2293 - PARKER, COLORADO
BAYOU GULCH RD AND PINERY PKWY
OVERALL SITE PLAN

2293 - PARKER, COLORADO
BAYOU GULCH RD AND PINERY PKWY
DETAILED SITE PLAN - NORTH

2293 - PARKER, COLORADO
BAYOU GULCH RD AND PINERY PKWY
ENLARGED GRADING PLAN - NORTH

DATE: 09-23-2022
SHEET NUMBER:
C1.2
6 OF 30

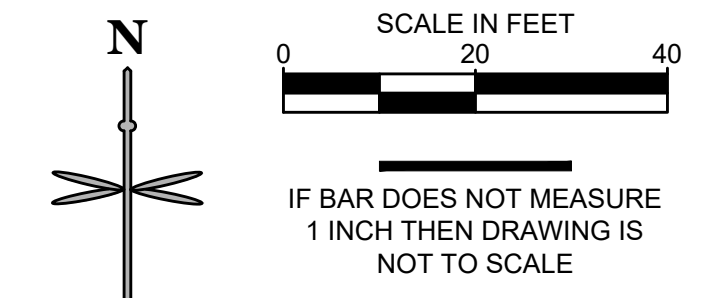
RELOCATE FROM 15' UE

EUSERC CABINET (PER CORE REQUIREMENTS)

SHEET NUMBER:
C2.2
11 OF 30

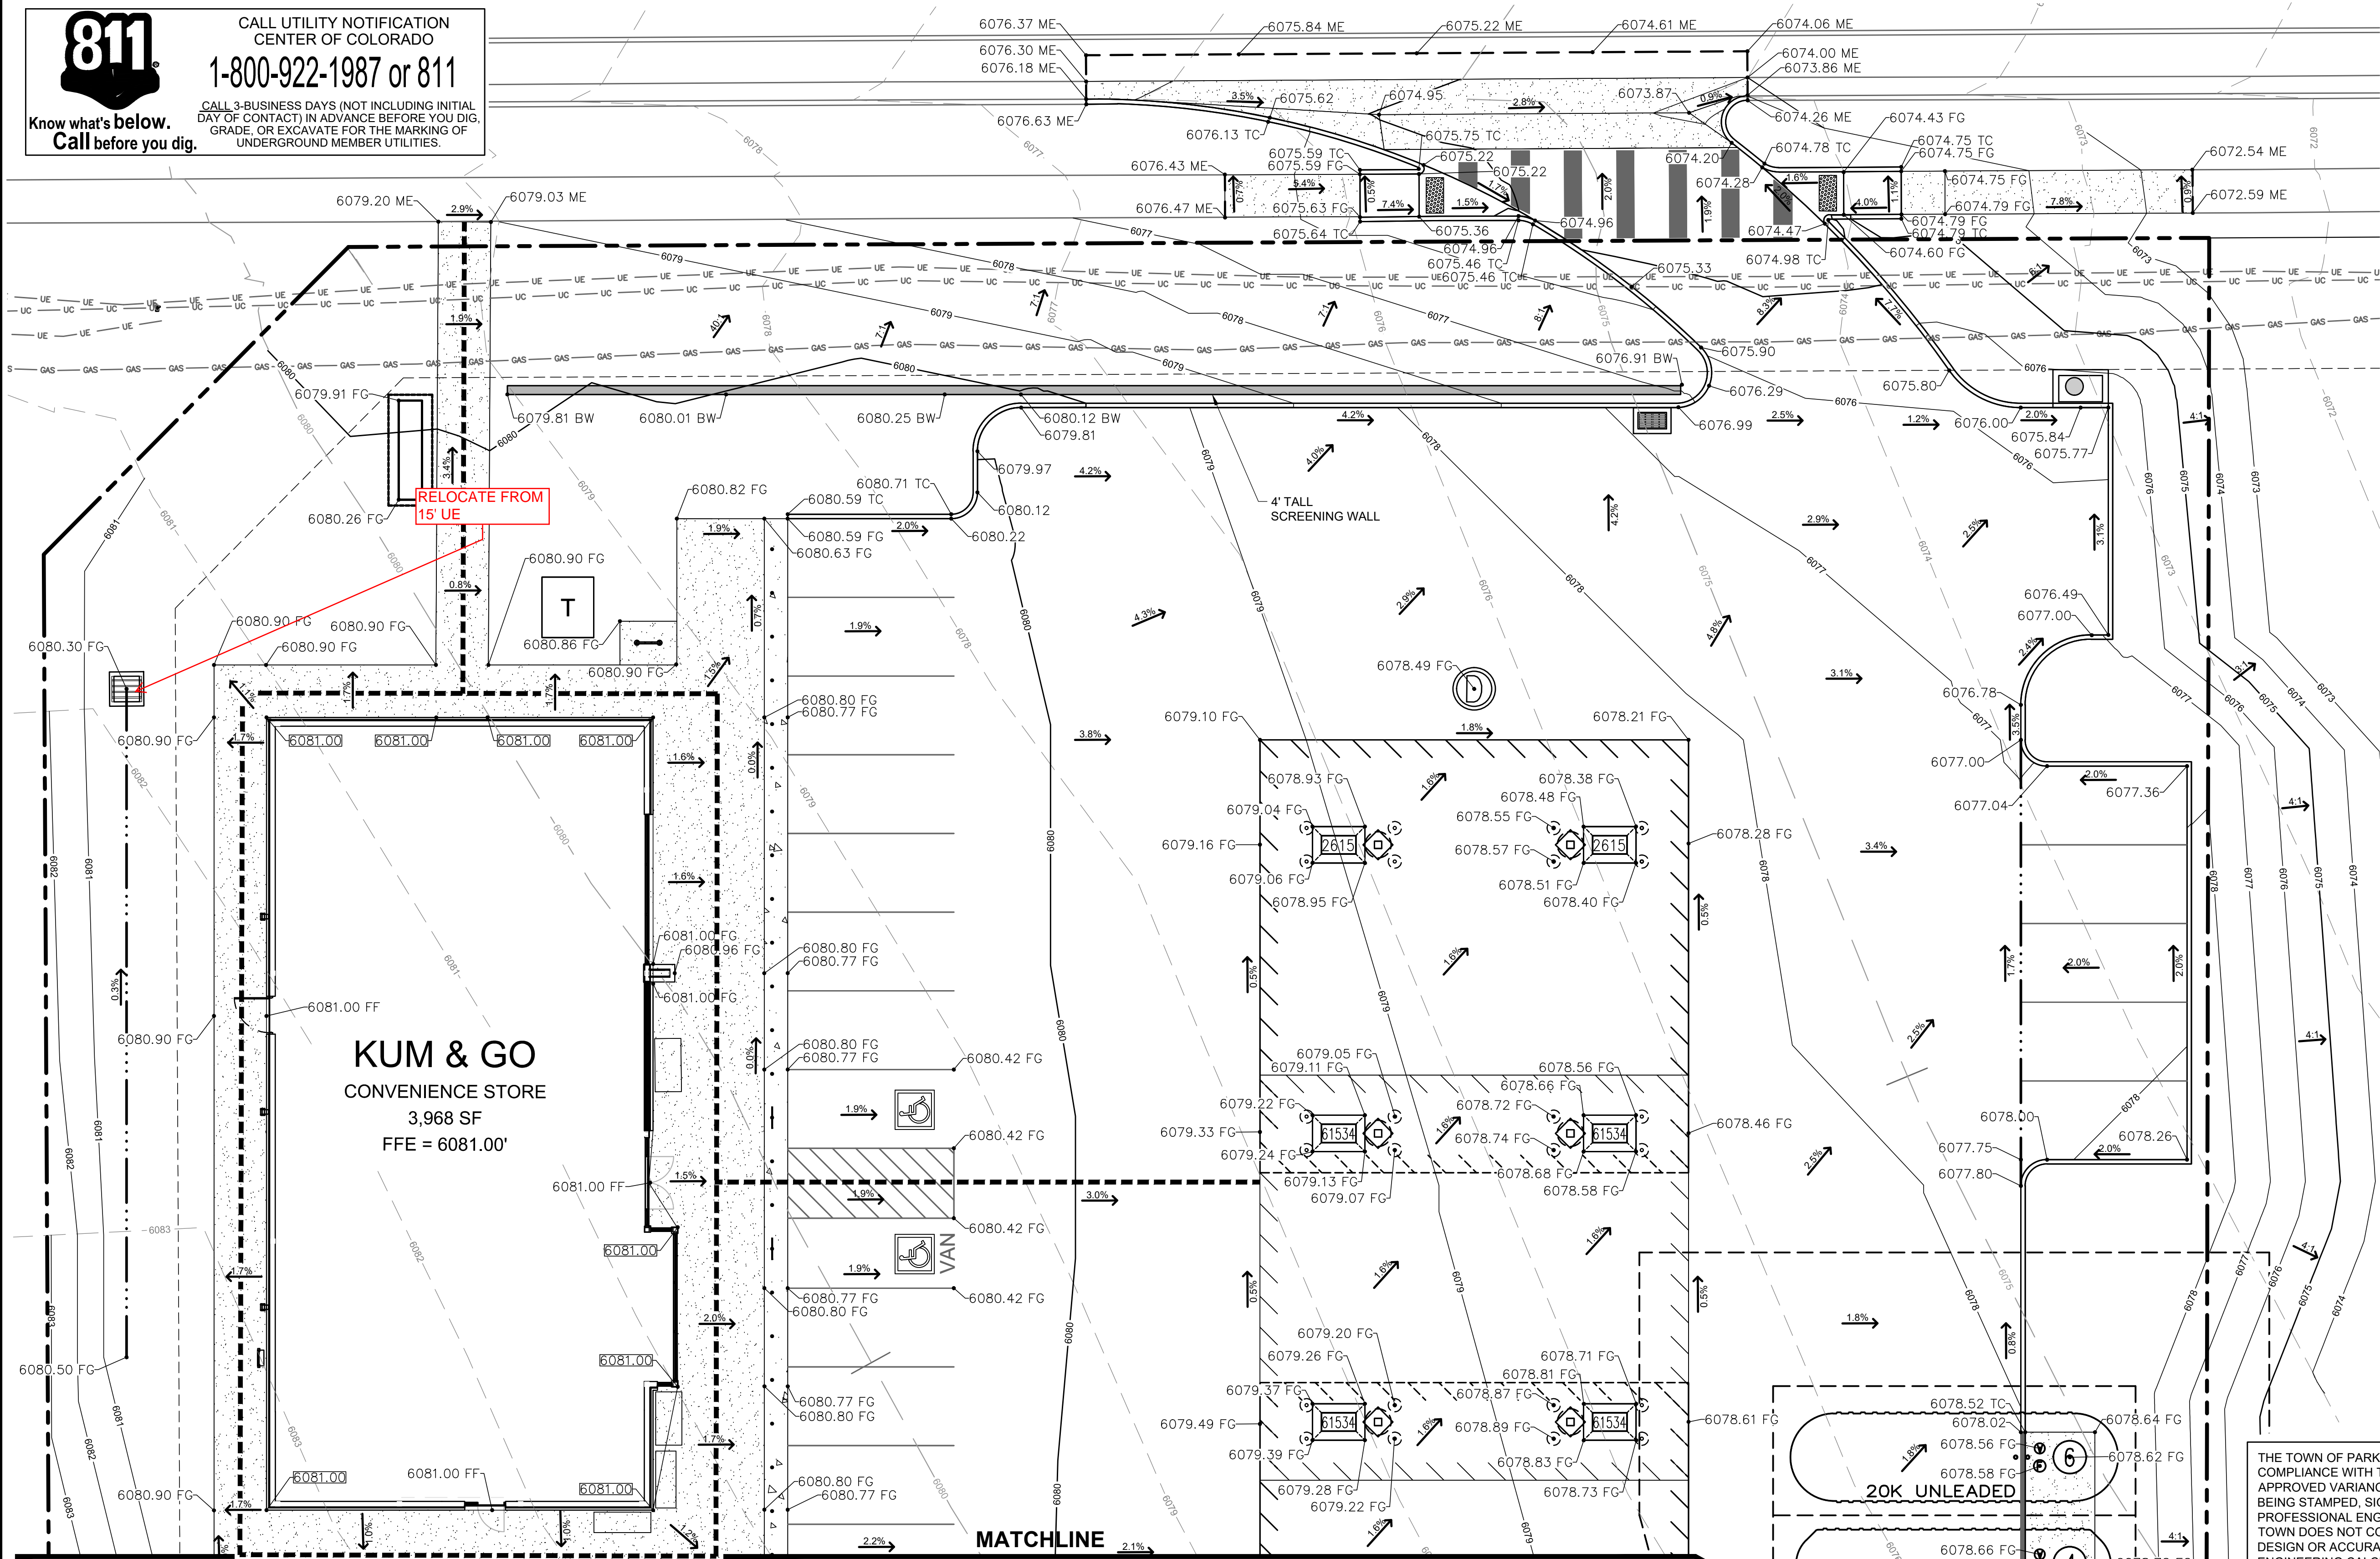
RELOCATE FROM
15' UE
